**HIGHLANDS COUNTY
BOARD OF COUNTY COMMISSIONERS**

BID NO.: ITB 17-014 ADDENDUM No. 1

Project: **SEBRING PARKWAY EMS STATION PROJECT NUMBER: 13061**

SECTION DETAIL N-N

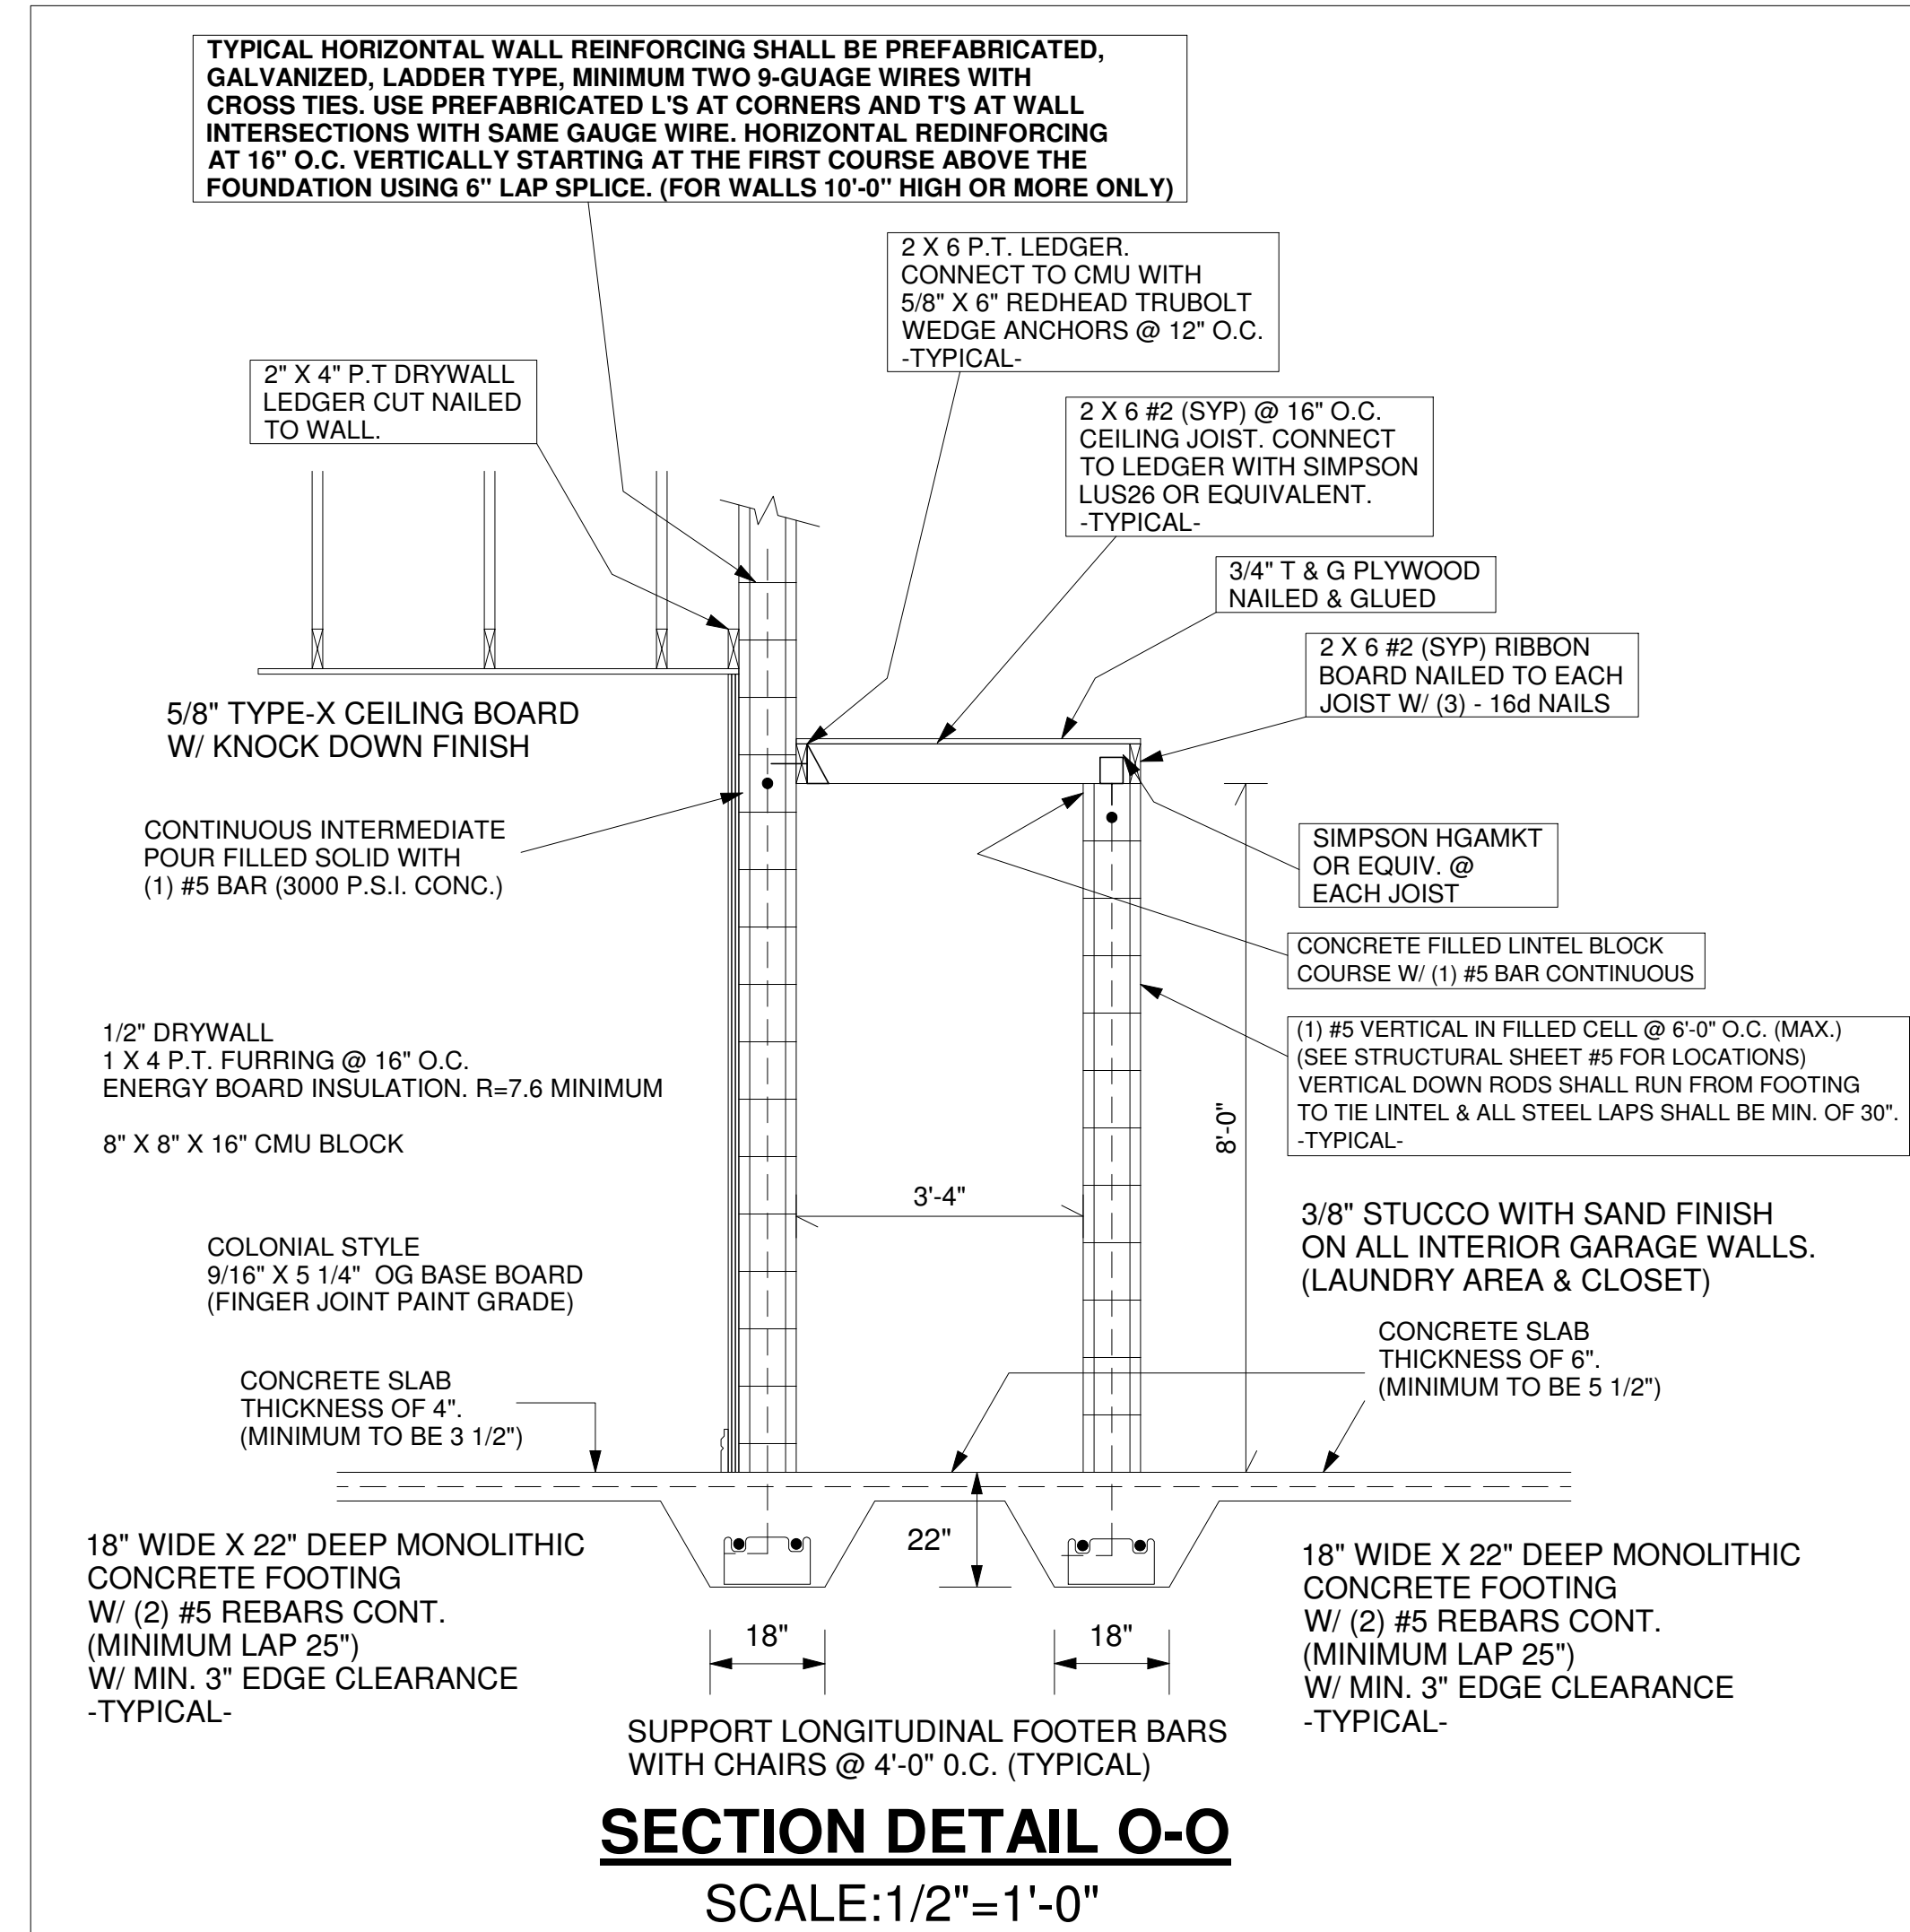
22. Are we to include any window sills?

A: This is indicated on the plans Section N-N.

DRAWING SCALE **1"=20'**
 SHEET **1 OF 6**

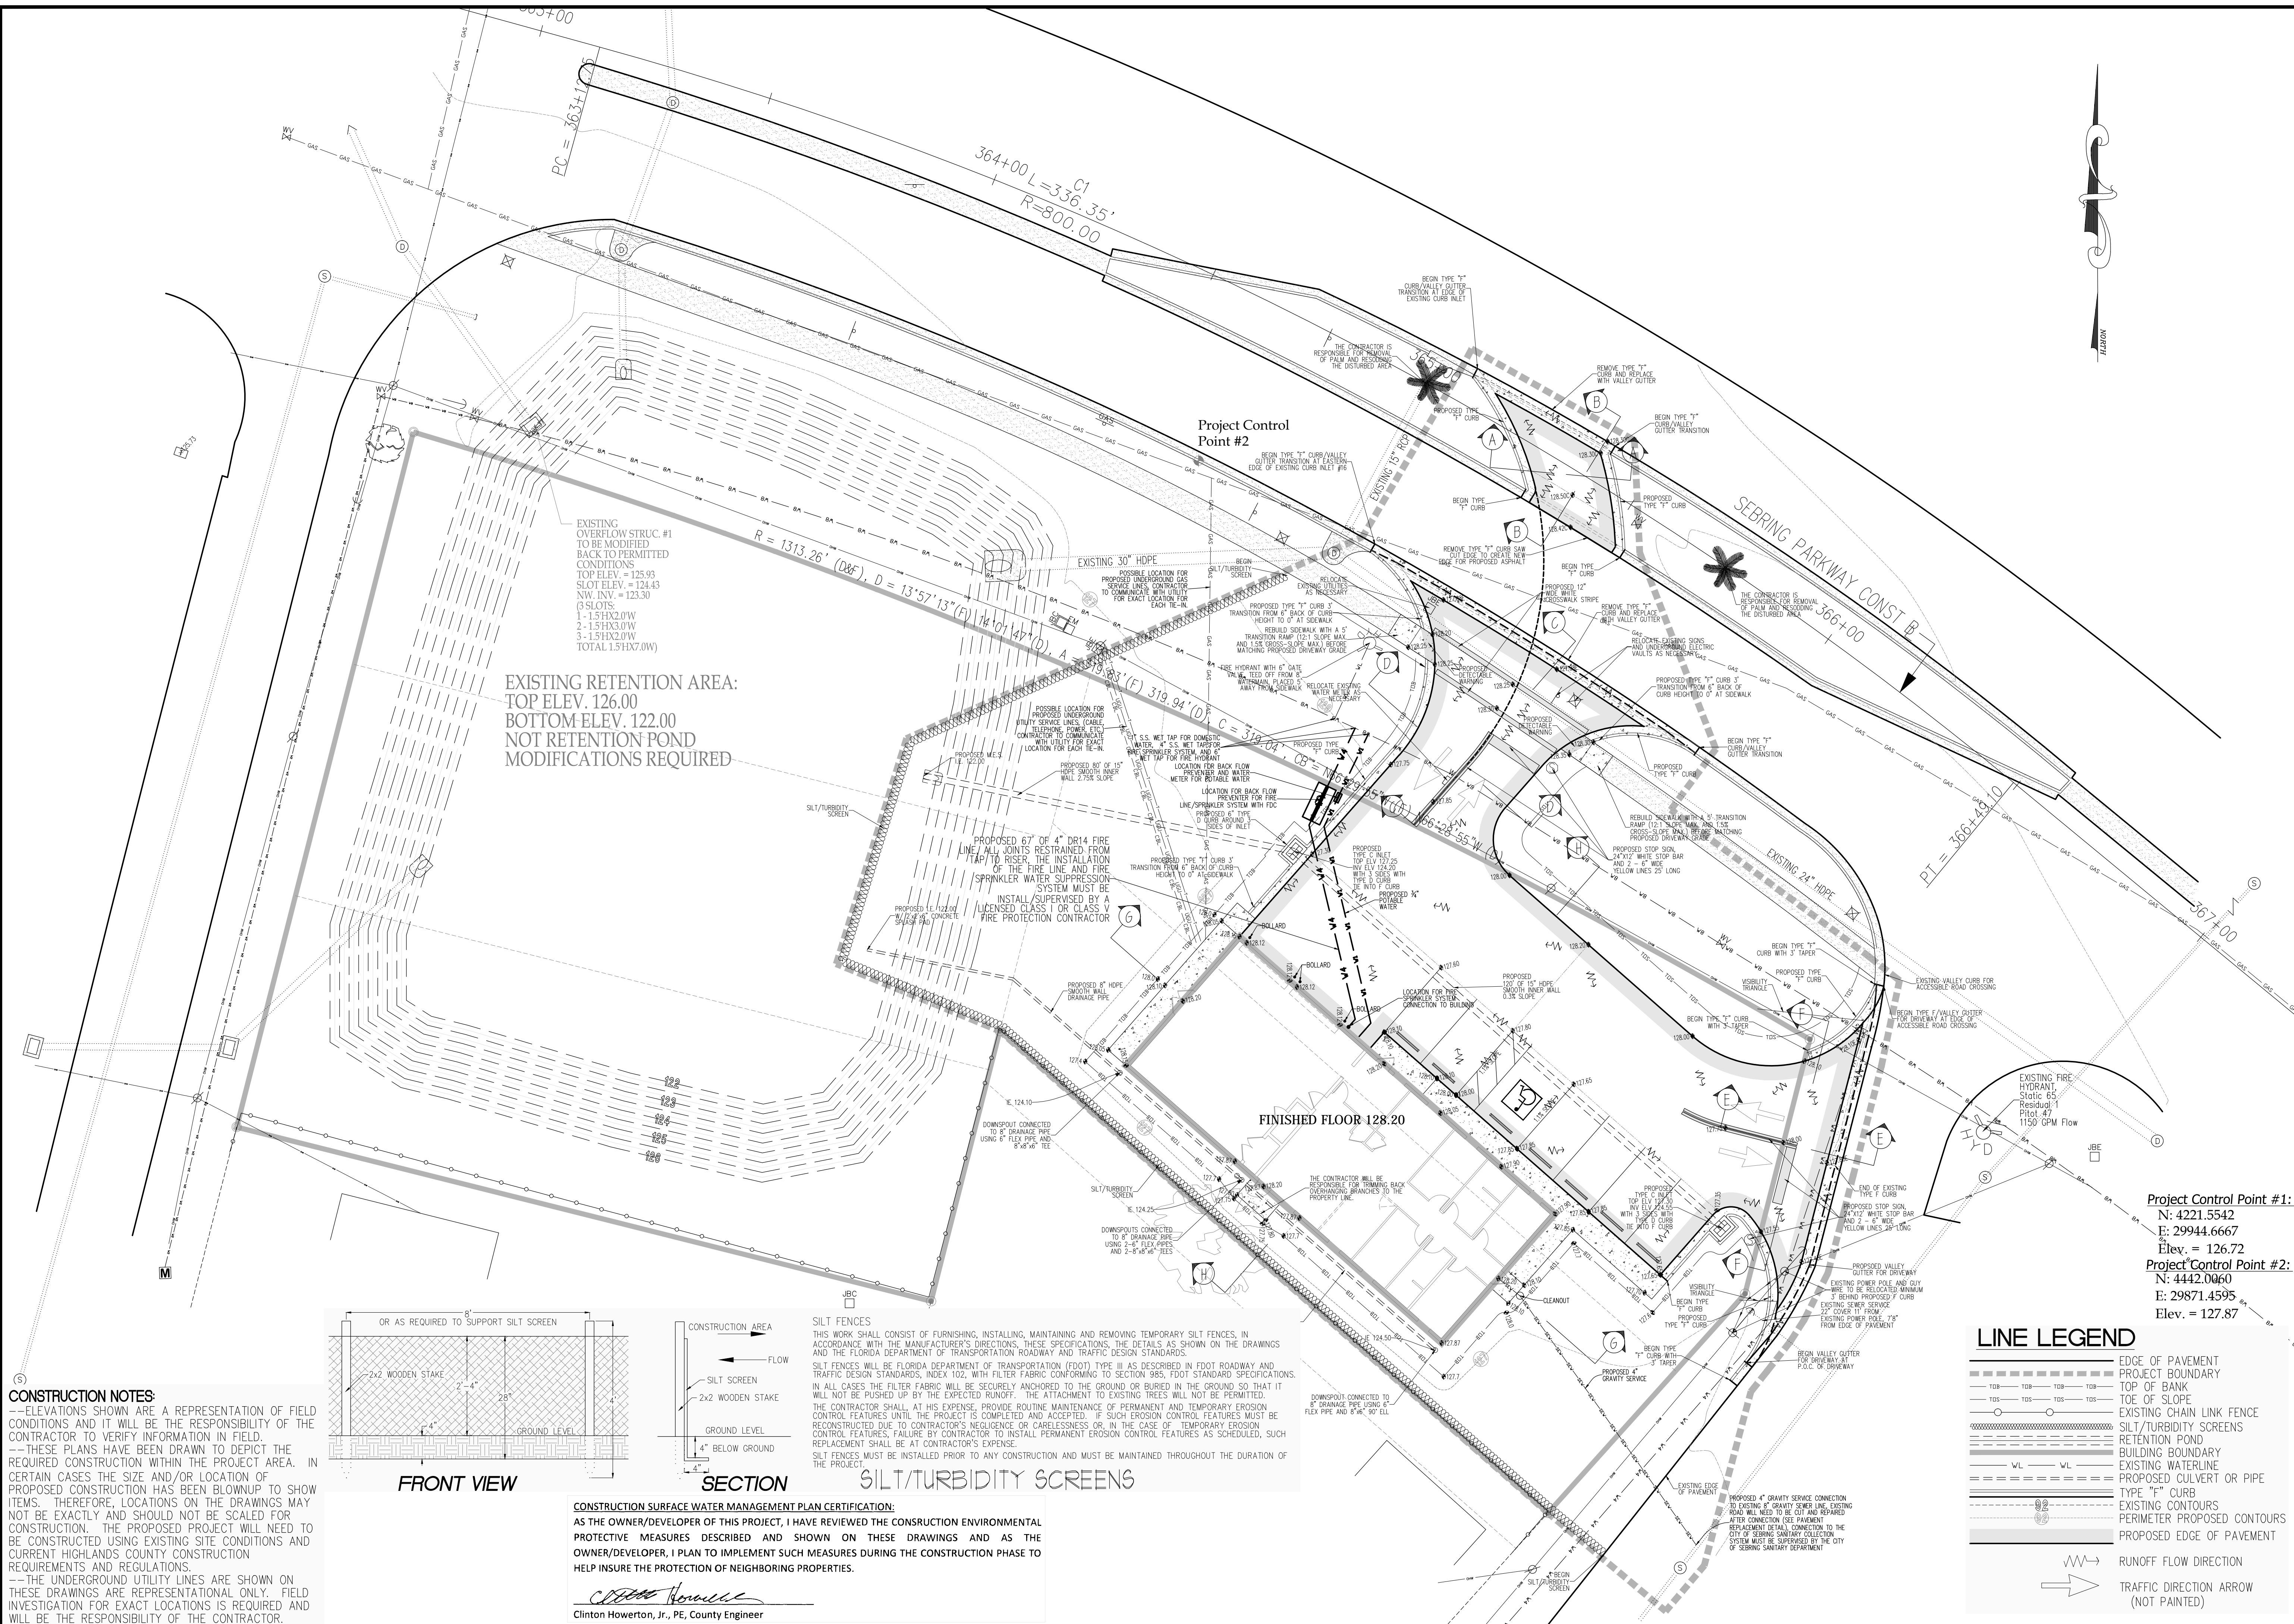
- a. The two palm trees adjacent to the new crossover in the median of the Parkway
The site plans have been modified to show the contractor is responsible of the removal of the 2 palm trees within the median adjacent to the new crossover.

- b. Regarding the trees on the neighbor's property overhanging branches to the property line.
The site plans have been modified and a note added stating the Contractor will be responsible for trimming back overhanging branches to the property line.

- d. The location of underground utility.

Underground utility connections are shown connecting to the western side of the building. The contractor will contact the appropriate utility to coordinate the connections.
